Burlington Development Review Board

BURLINGTON DEVELOPMENT REVIEW BOARD

MEMORANDUM

RE: ZP22-45, 44 Lakeside Avenue (also known as 32, 44 and 50 Lakeside Avenue)

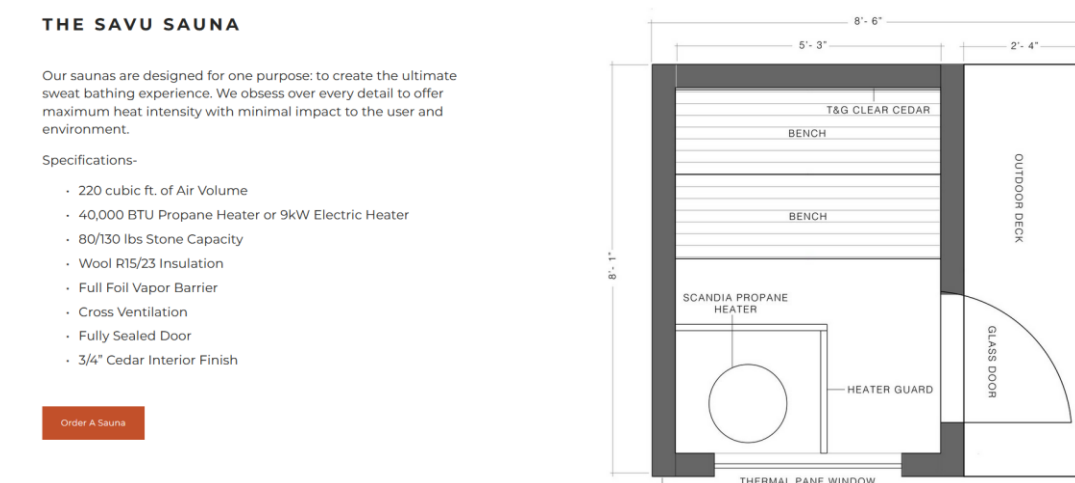
These are small, portable structures that will have a negligible impact on the overall site. From their website, the footprint looks like this:

Both the changing rooms and the office will be 8 x 12 boxes; the former divided in half to accommodate clients. **Affirmative finding.**

SITE PLAN

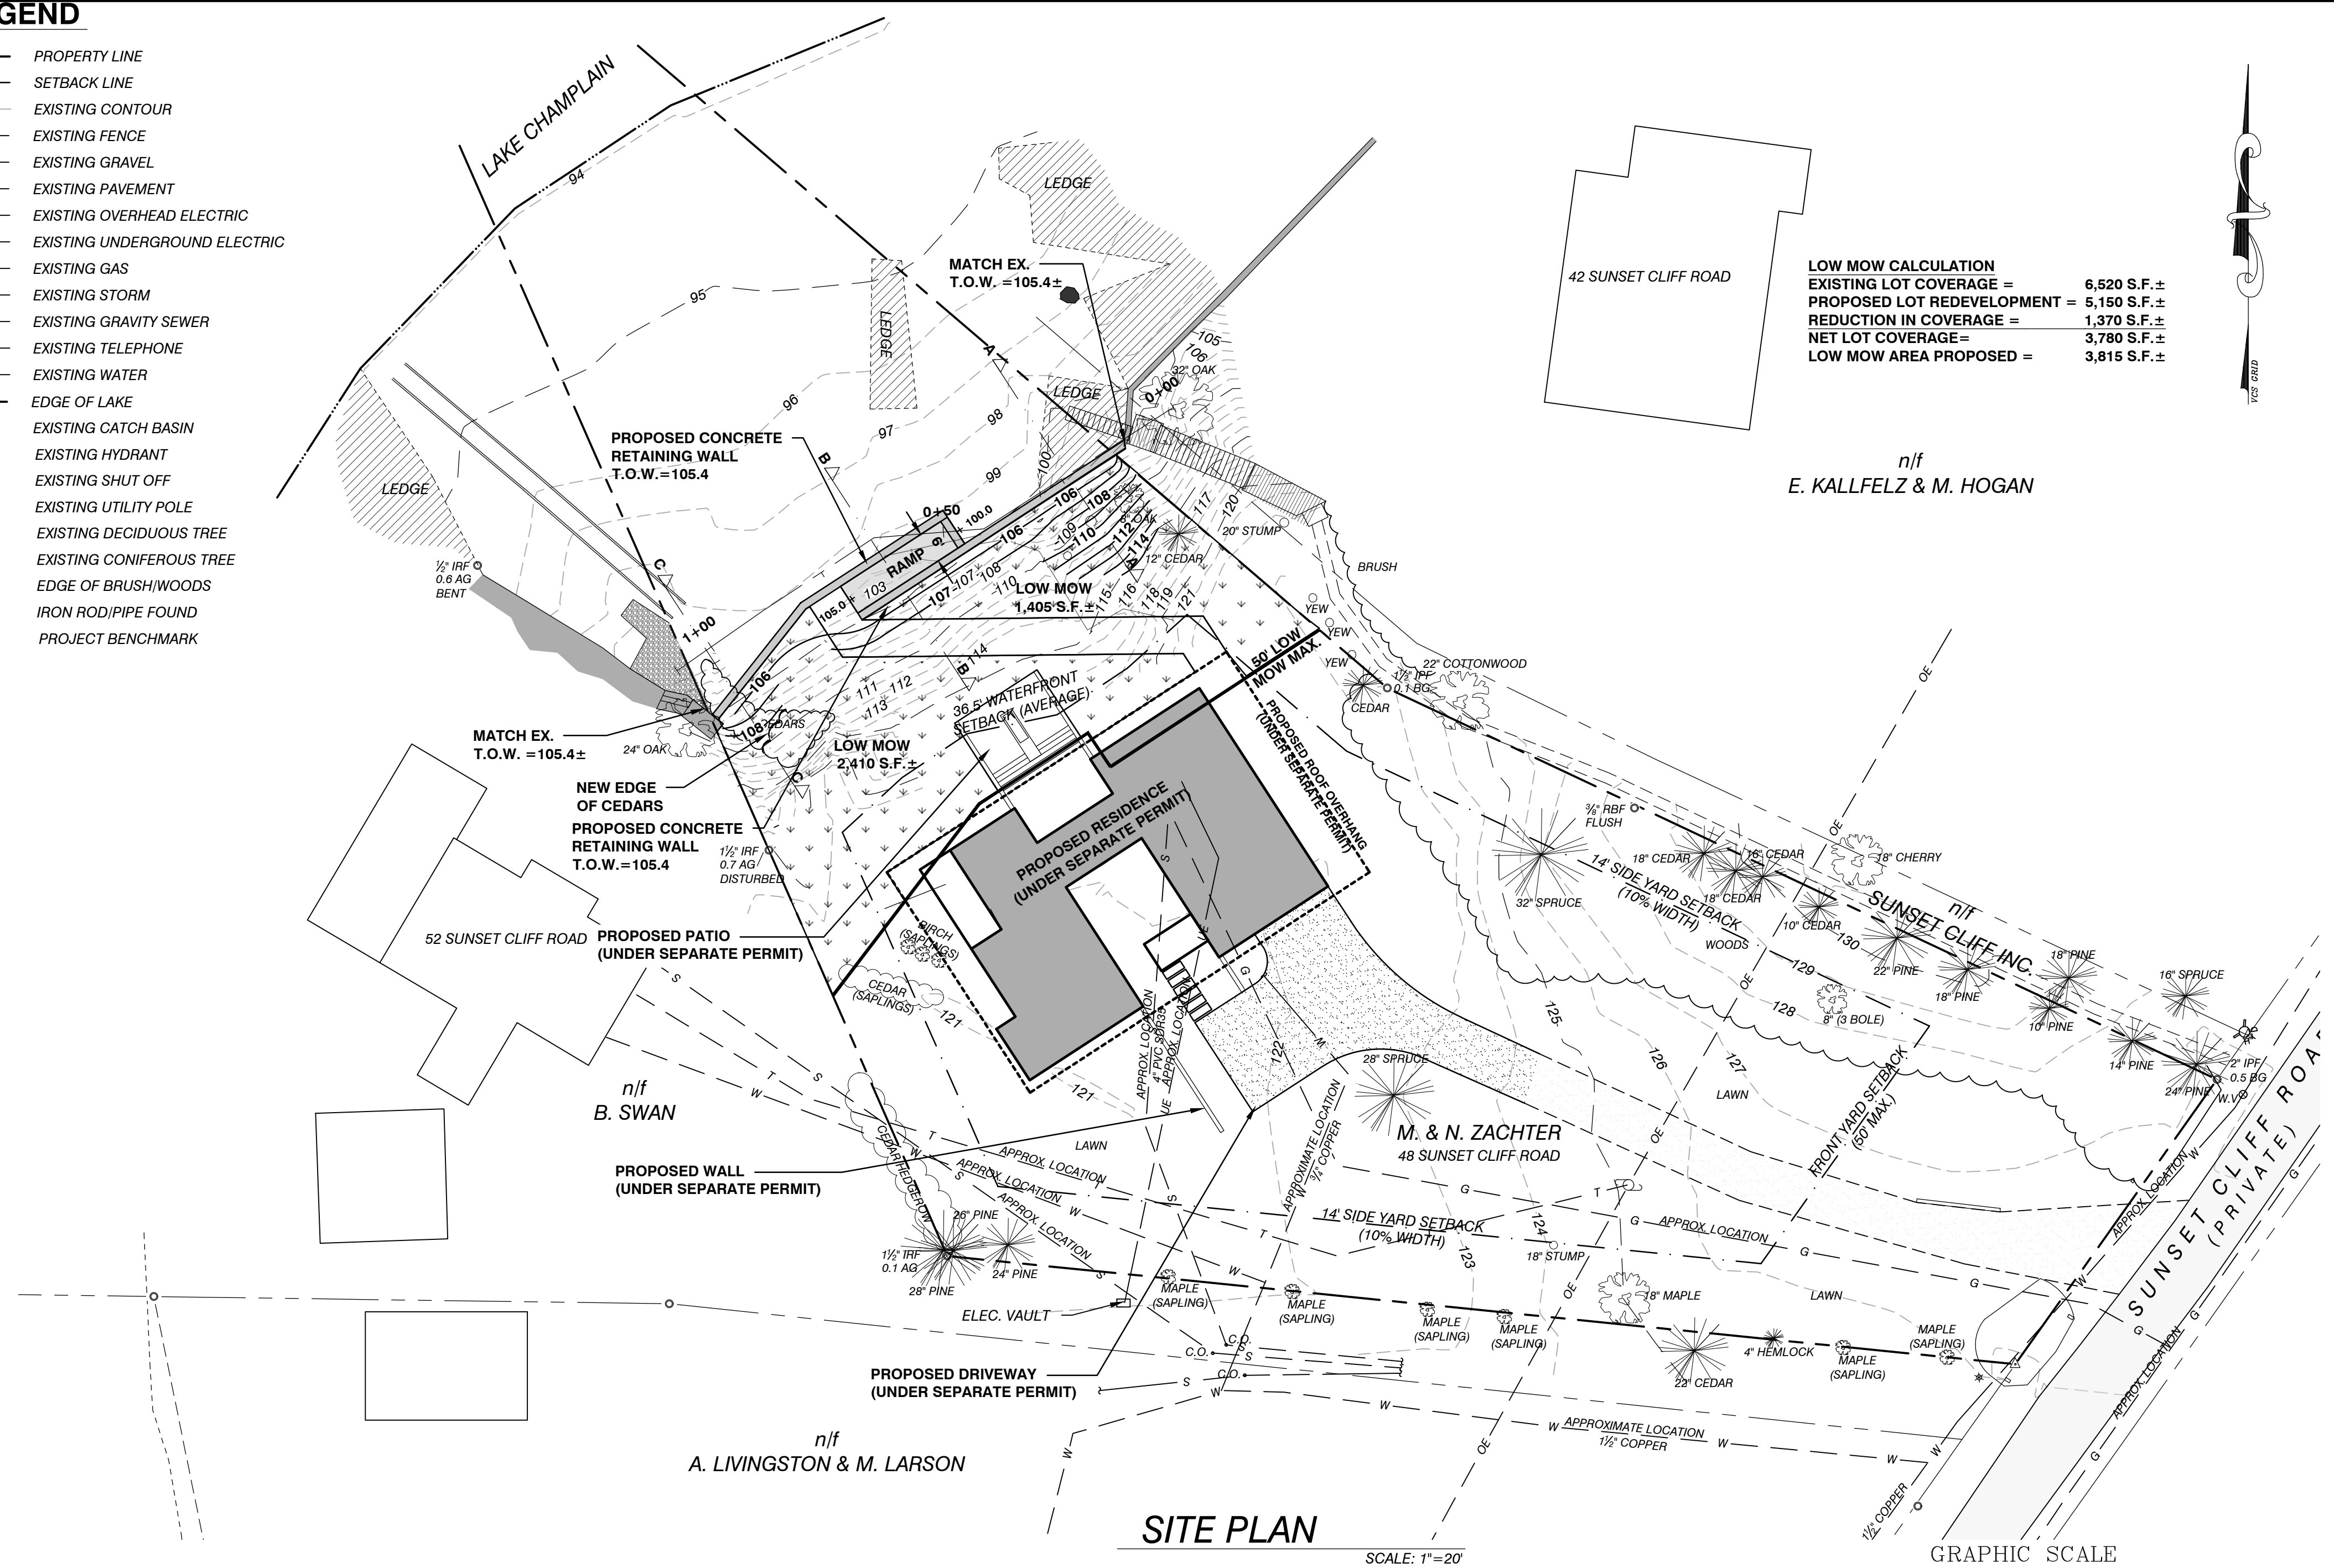
Based on the conceptual lot coverage for the replacement single-family residence, the required “low mow zone” is depicted on the enclosed sheet C2.0. The area of the proposed low mow zone exceeds the City’s requirements. Please refer to calculations included on enclosed sheet C2.0.
